CASE #PL2020-112

MINNESOTA
CAMPUS PARKING
RAMP

Issued For
Item Date
CITY SUBMITTAL 07-08-2020

SITE PLAN

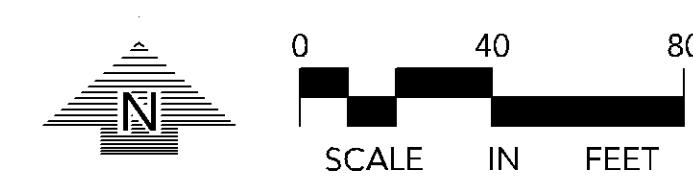
Provide adequate turning radius for all emergency vehicle access lanes.

Provide a circulation route to/through the existing campus that doesn't create a dead end situation during construction.

Gate Must Be Accessible

Is it possible to not have fence next to the building?

Gate Must Be Accessible

Gate Must Be Accessible
220.CS

CIVIL DETAILS

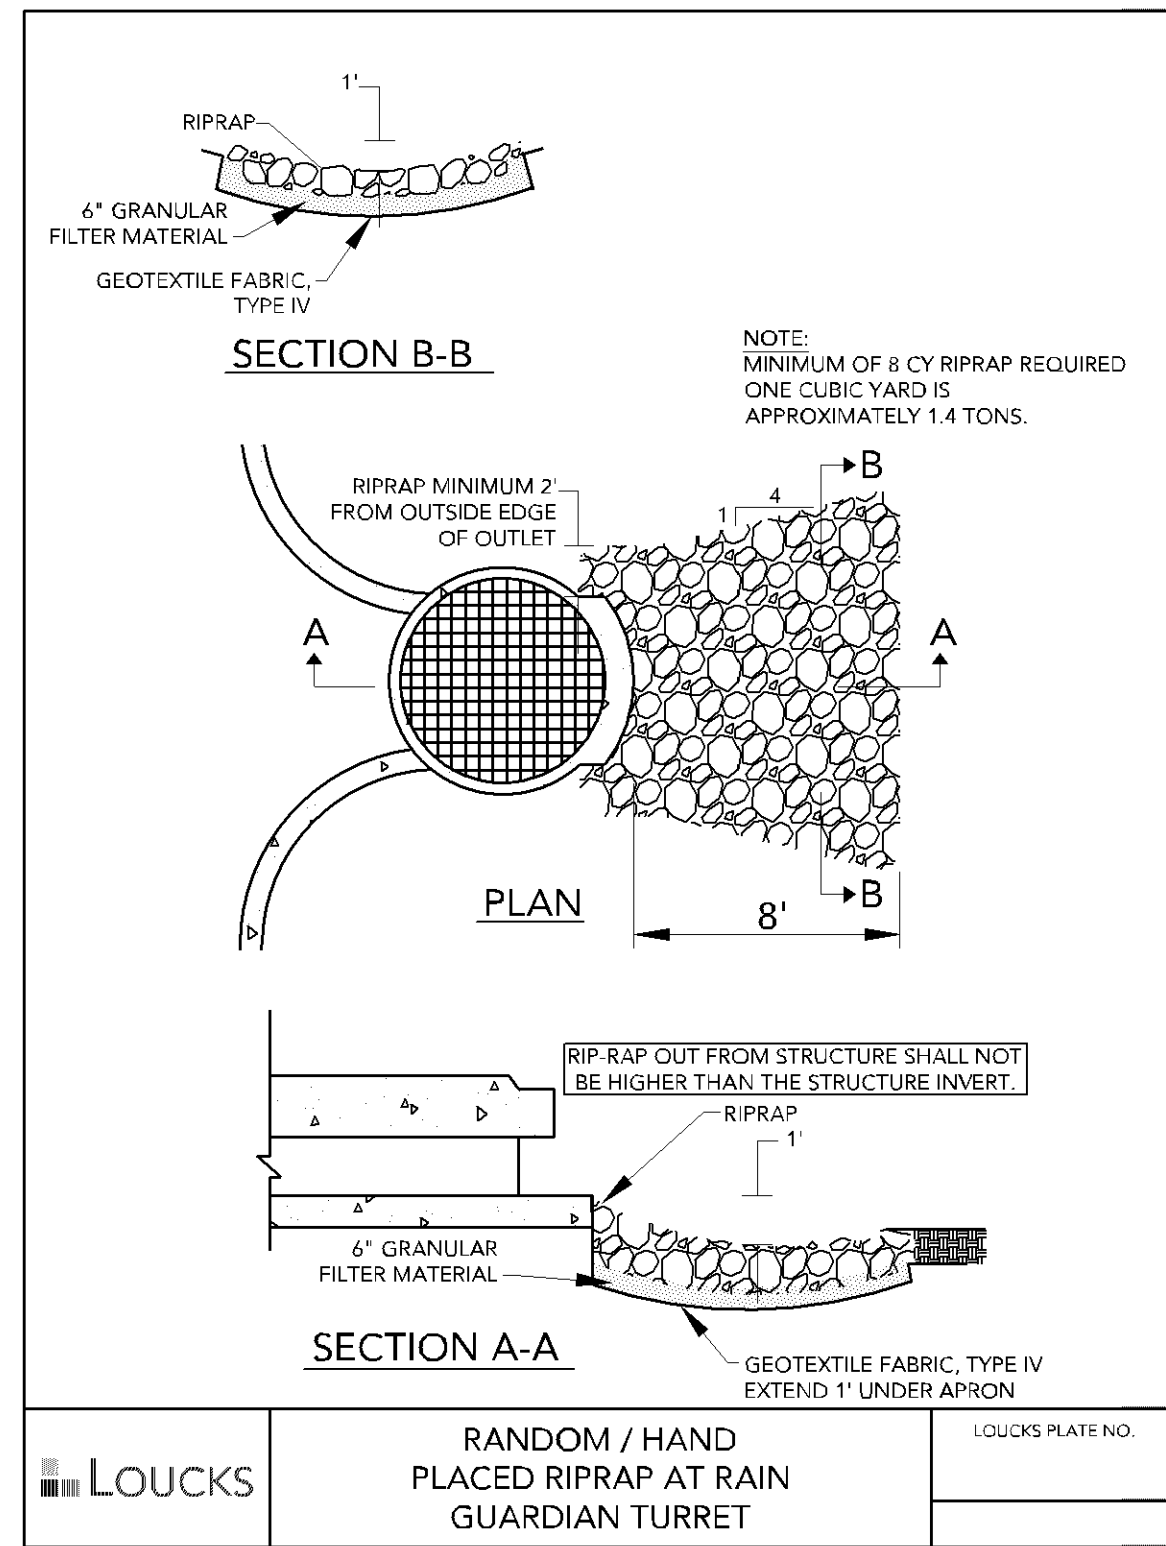
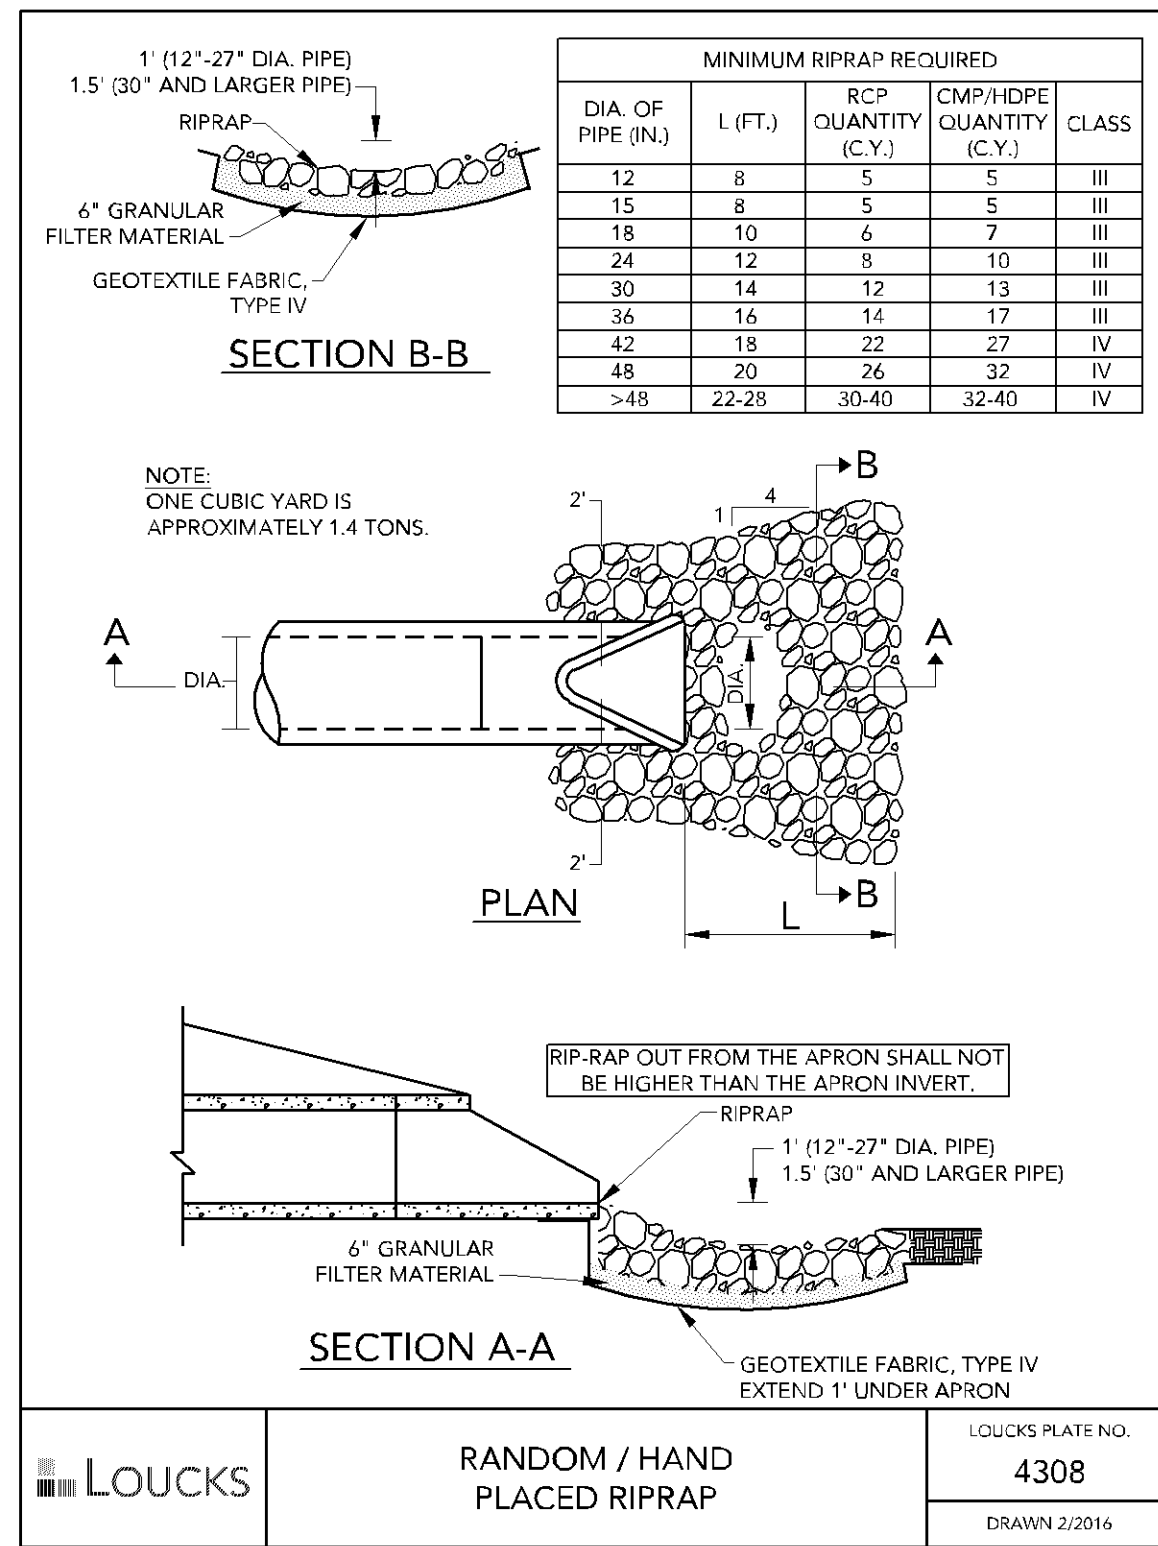
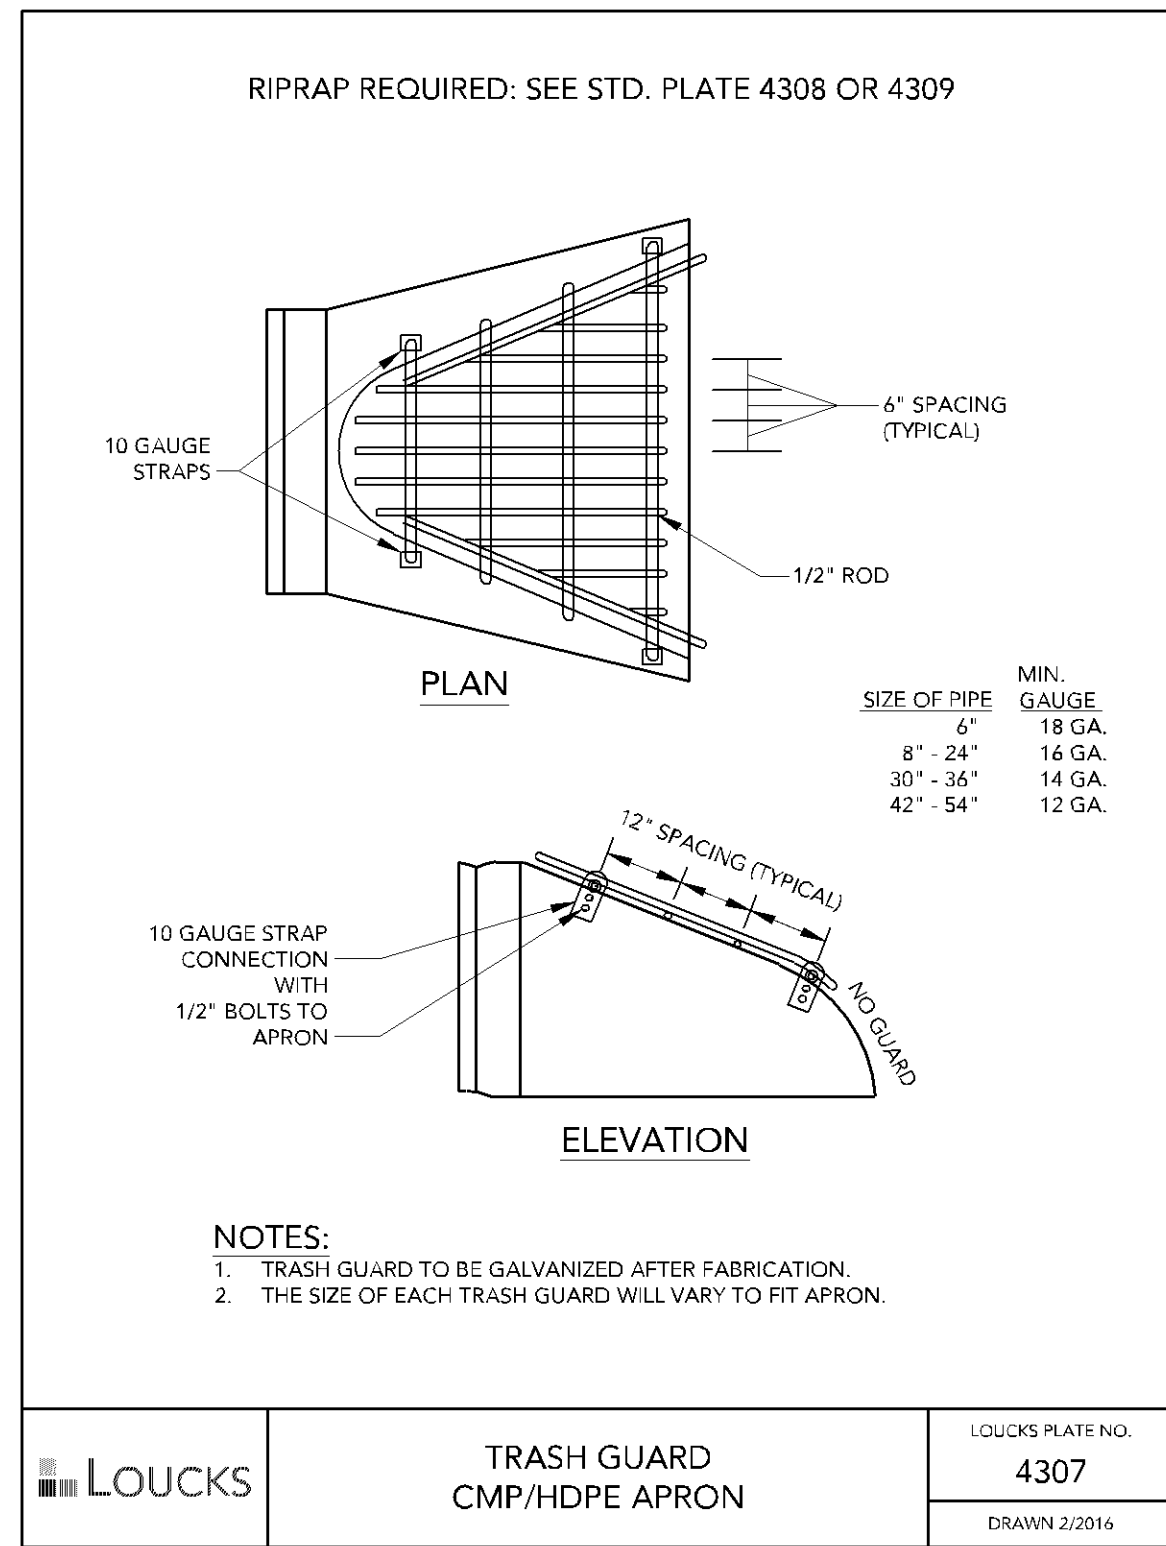
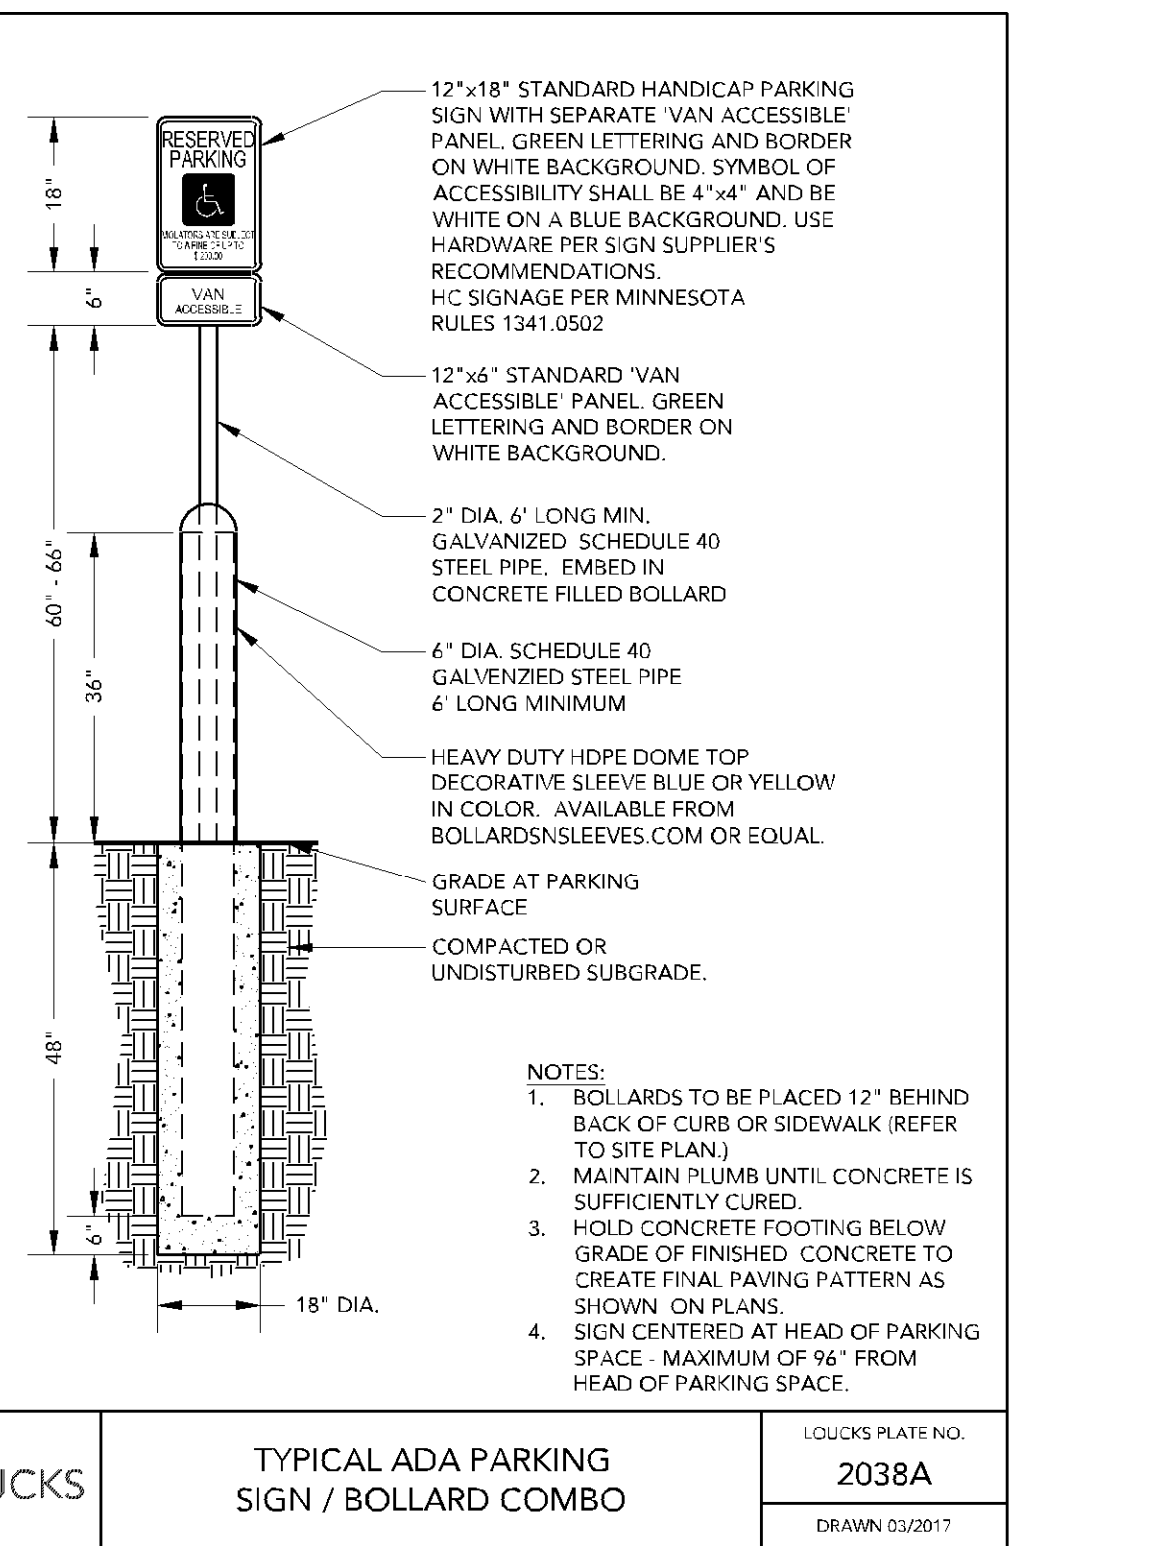
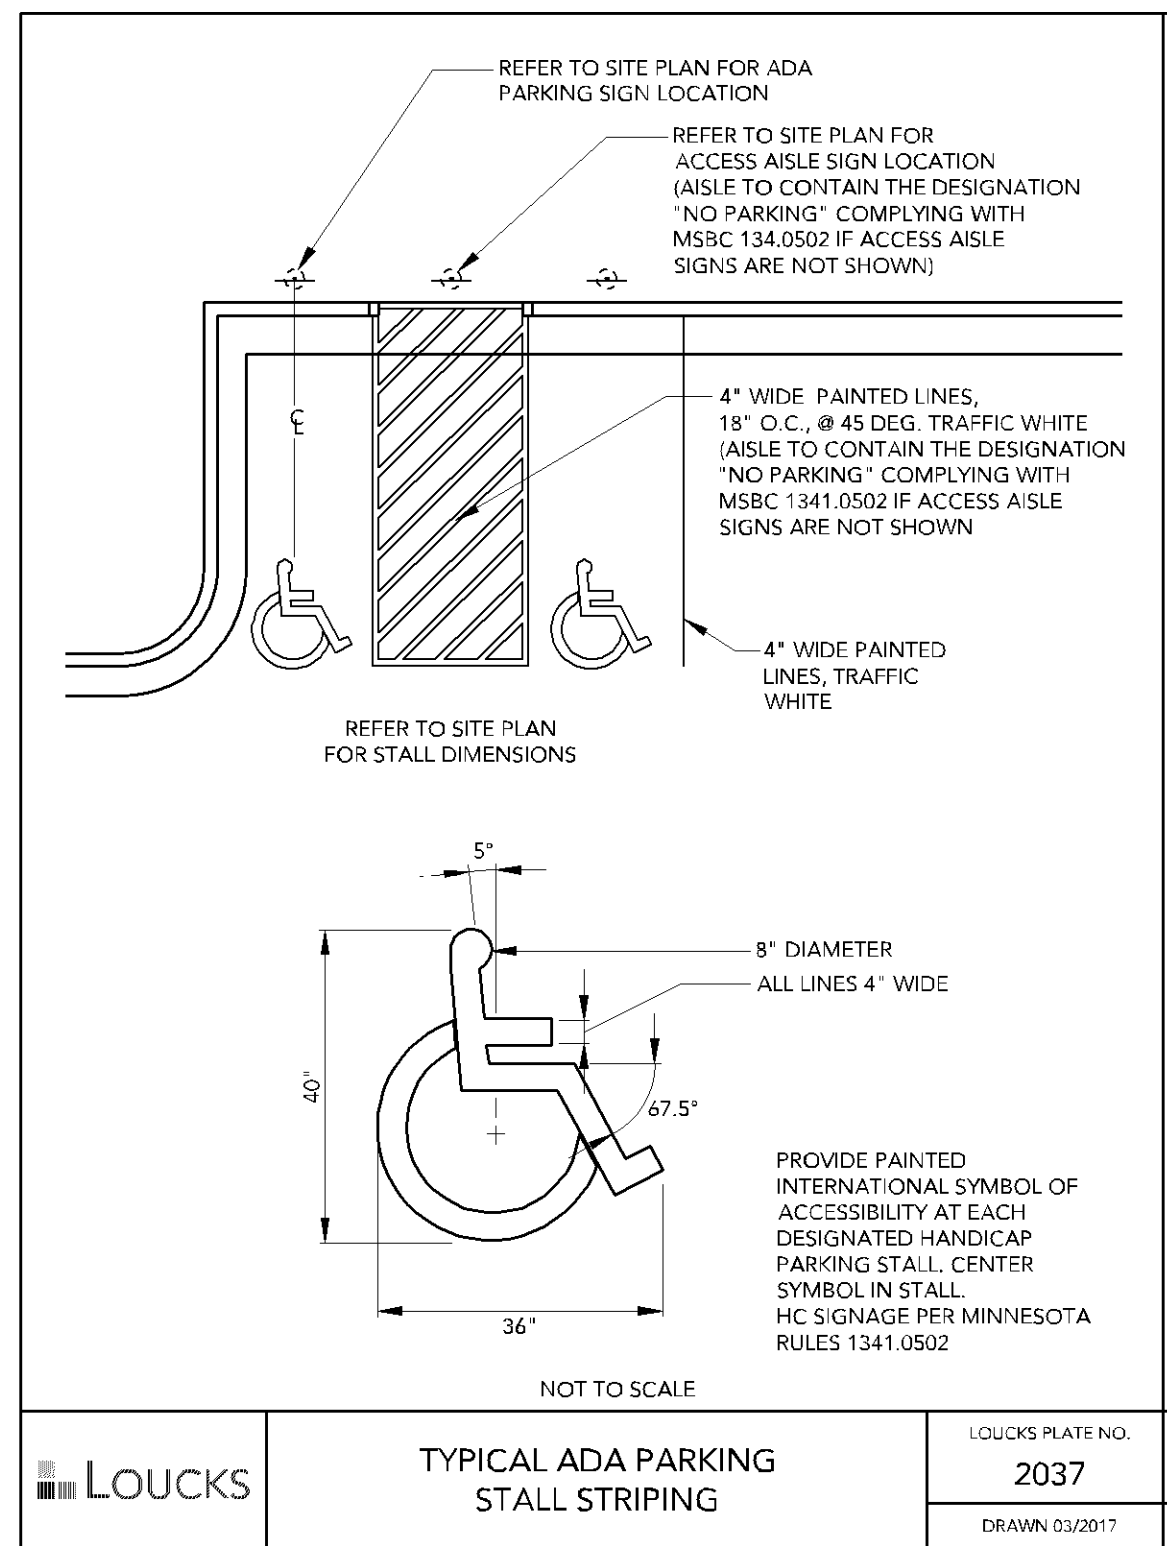
Provide thrust block detail, see City website
